# City of Alexandria, Virginia

## MEMORANDUM

**SUBJECT:** 4<sup>th</sup> CONCEPT REVIEW OF 500 & 501 NORTH UNION STREET  
(FORMERLY ROBINSON TERMINAL NORTH)  
BAR CASE # 2014-0119

A8

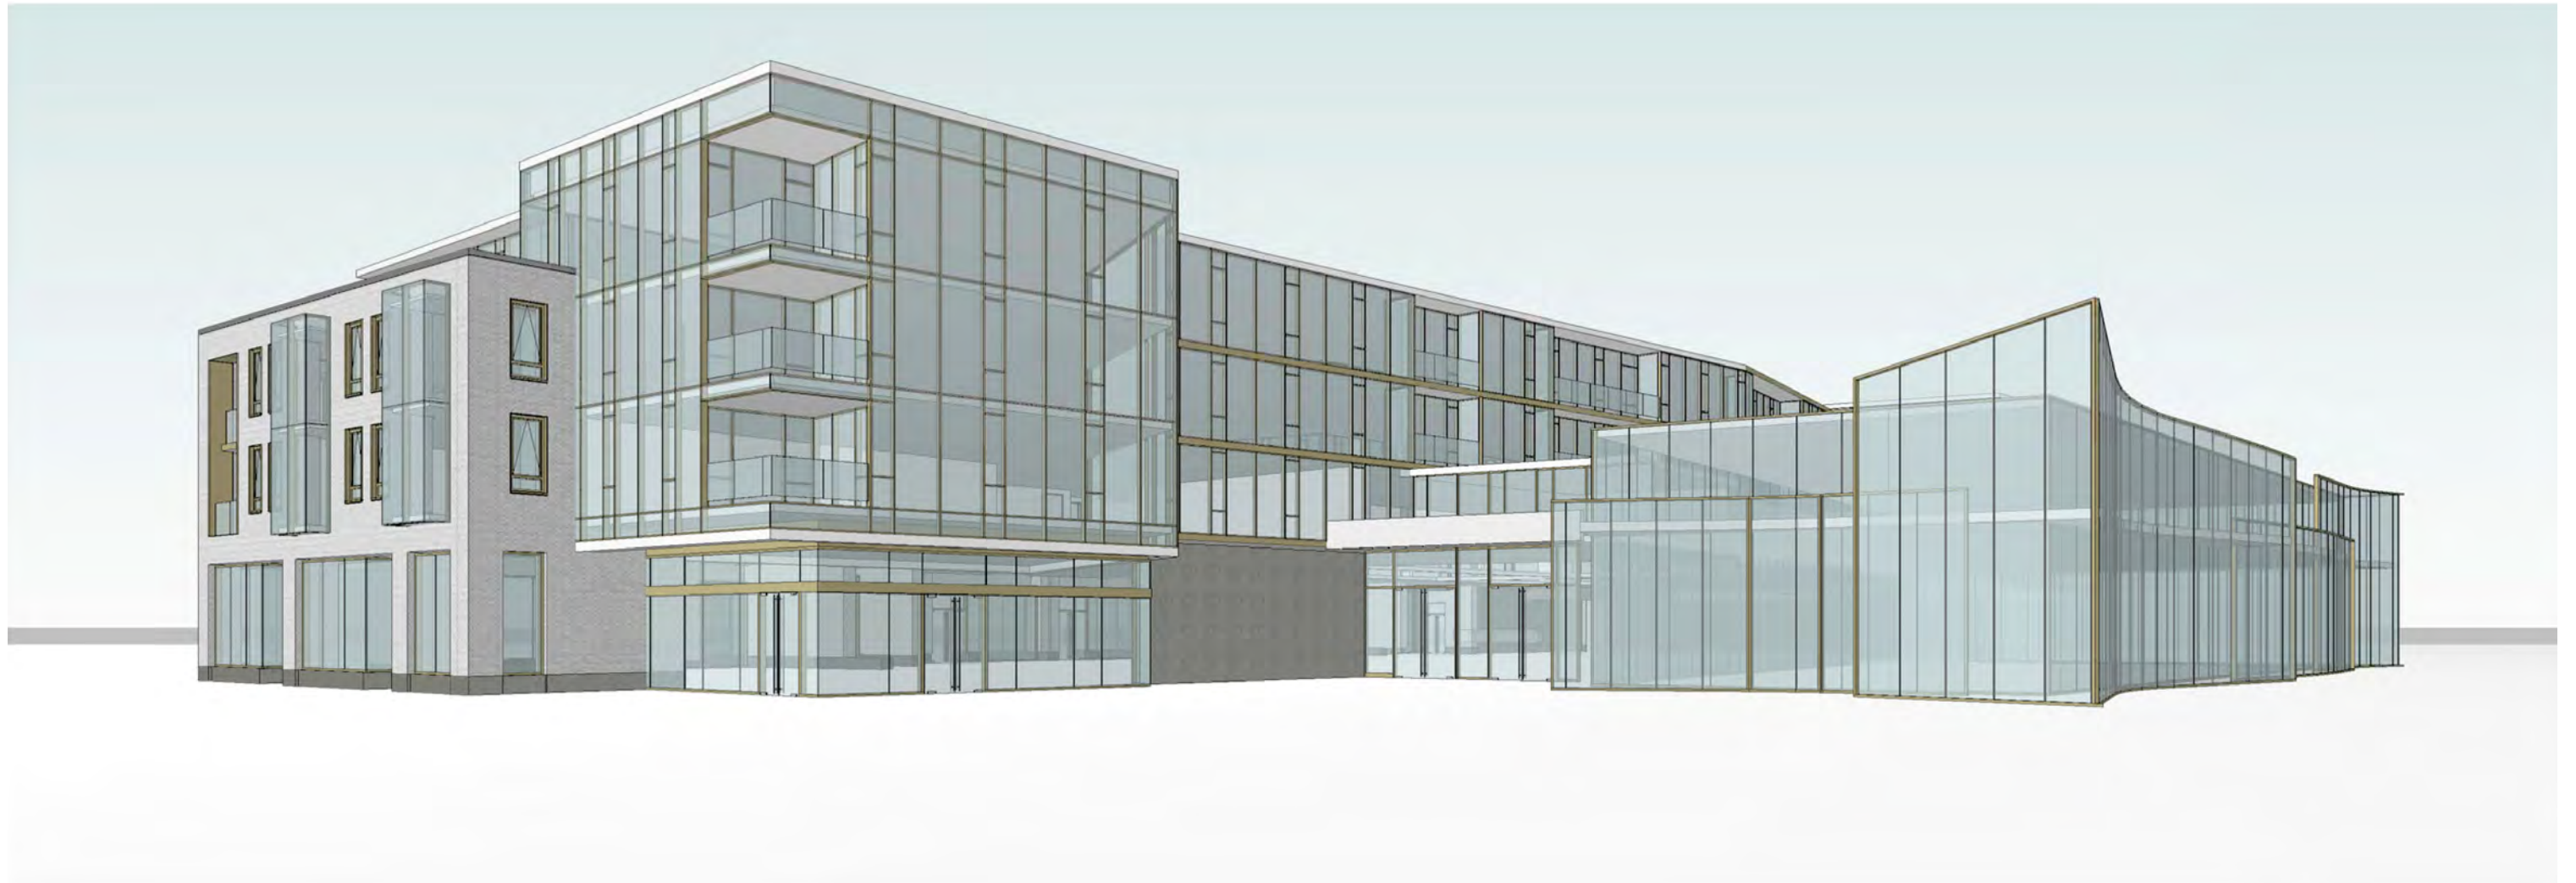
Like the east elevation, the north elevation facing the river is largely glass, as recommended by the BAR, and floats above the stone art wall/loading dock screen (Sheet A8). The applicant acknowledges that this elevation is the least developed at the present time and requires work around the loading dock entrance to maintain adequate utility screening, provide visual support for the upper floors and integrate the historic interpretation artwork on the stone wall.
